APPENDIX-A

Amendment to Tender IISERM (1634) 23/24-Pur

Answers to the prebid queries/ representations received bidders/ vendors

Annexure - III-A

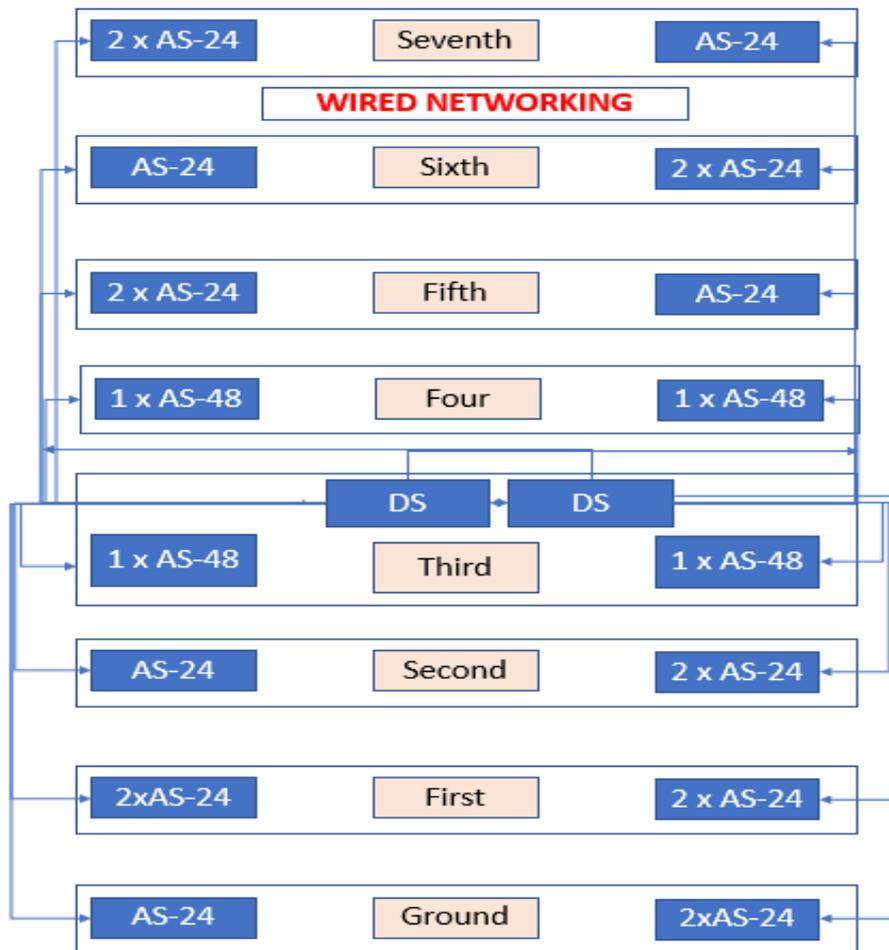
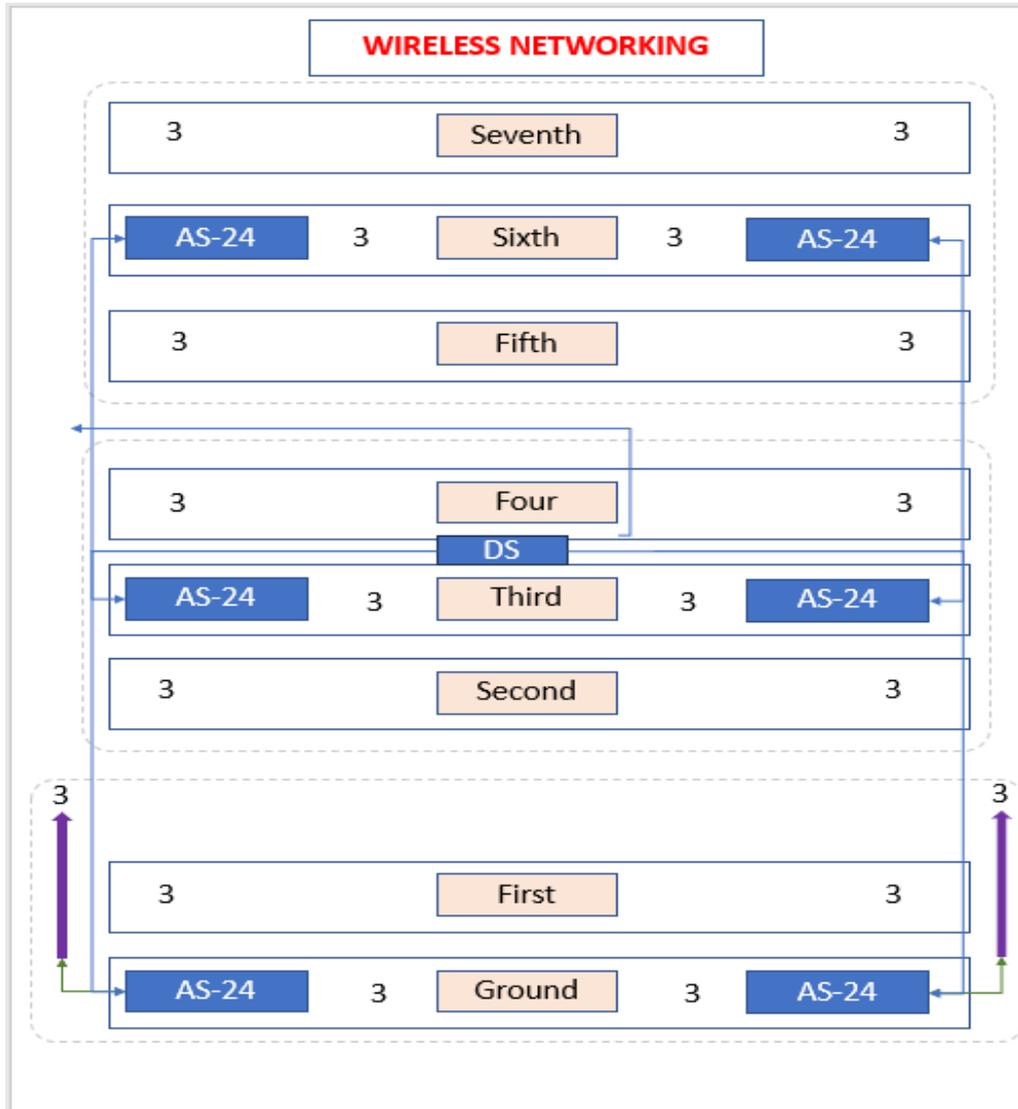
2. Annexure I-A indicates the minimum requirement of wired IO outlets. Annexure - III-A and Annexure - IV-A provide the minimum required of switches for wired and wireless networking respectively.
 - a. The minimum required IOs may not be the same as the available total ports (AS) as per the required switches.
 - b. Total ports available on DS may be larger than the sum of required ports on all AS.
 - c. Total ports available on CS may be larger than the sum of required ports on all DS.

Floor No	No of AS -24 ports	No of AS - 48 ports
7	3	0
6	3	0
5	3	0
4	0	2
3	0	2
2	3	0
1	3	0
Ground floor	3	0
Total	18	4

Total number of 48 port switch = 4
 Total number of 24 port switch = 18
